**Comments on Application for Variance or Appeal filed on behalf of Cornell by
Thomas D. Hoard, HOLT Architects, P.C., dated 13 September 2013**

Submitted by Jonathan Ochshorn, Oct. 10, 2013

Milstein Hall is an addition to both Rand and Sibley Halls on the Cornell University campus in Ithaca, NY that created a single building, Rand-Sibley-Milstein Hall. A certificate of occupancy was issued on Feb. 24, 2012. The variance application submitted by Thomas Hoard on behalf of Cornell University to place a noncompliant library assembly occupancy on the second and third floors of Rand Hall (part of Rand-Sibley-Milstein Hall) should be seen in the following context:

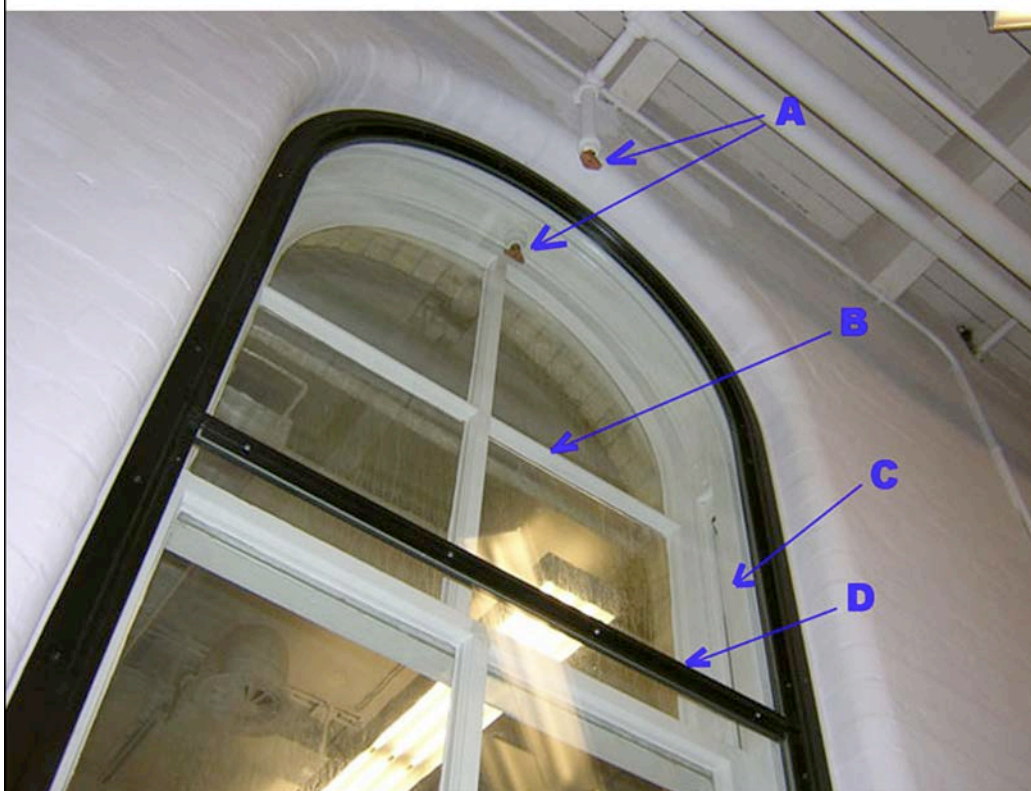
First, the fire barrier between Milstein and Sibley Hall at the second-floor level does not meet the minimal requirements for a 1-hour fire-rated wall under the 2002 BCNYS – Cornell admitted in testimony at the Hearing for Petition No. 2013-0250 that opening protectives for window areas, in excess of the allowable 25% aggregate width limit, were covered with 3/4-hour fire-resistance rated glazing instead of the required 1-hour fire-resistance rated glazing. An attempt to remedy this error by providing Tyco Model WS Specific Application Window Sprinklers was conditionally approved by the Review Board at the Hearing for Petition No. 2013-0250 (Exhibit 3), subject to a "submittal from the City of Ithaca on the testified approvals from the compliance testing lab." The submitted document, incredibly, contains the same NER-516 "Legacy Report" that Cornell had already referred to at the Hearing – a report that specifically *prohibits* the use of Tyco sprinklers in the way that Cornell used them. As shown in Figure 2 below, this system is noncompliant if the glazing has intermediate horizontal mullions, *or* if combustible material is within two inches of the glazing. The Sibley-Milstein fire barrier openings fail not only one of these tests, but fail both of them. In other words, the petitioner is requesting a variance to *leave existing fire barriers in place*, rather than

upgrading the Rand-Milstein fire barrier per the requirements for changes of occupancy under the 2010 EBCNYS, yet even the minimal standards for a 1-hour fire-resistance rating, mandated by Section K902.2 of the 2002 BCNYS, have not been complied with.

7.3 The glazing assembly shall not have intermediate horizontal mullions.

7.1 The only glazing assemblies not included in the definition of wet-type sp. materials that or load-bearing assemblies are outside the scope of this report.

7.8 All combustible materials shall be kept 2 inches (51 mm) from the face of the glass. This can be accomplished by a 36 inch (914 mm) pony wall.

Figure 2. Fire-rated glazing with special Tyco sprinklers (bottom image, photo by J. Ochshorn) does not meet the requirements for a 1-hour fire-resistance rating outlined in the NER-516 "Legacy Report" submitted by Cornell; the system as installed by Cornell has intermediate horizontal mullions (labeled as "D" in the photo) and combustible material within two inches of the glazing (labeled as "C" in the photo), either of which render the entire assembly noncompliant. The specific NER-516 requirements are reproduced at the top of the figure.
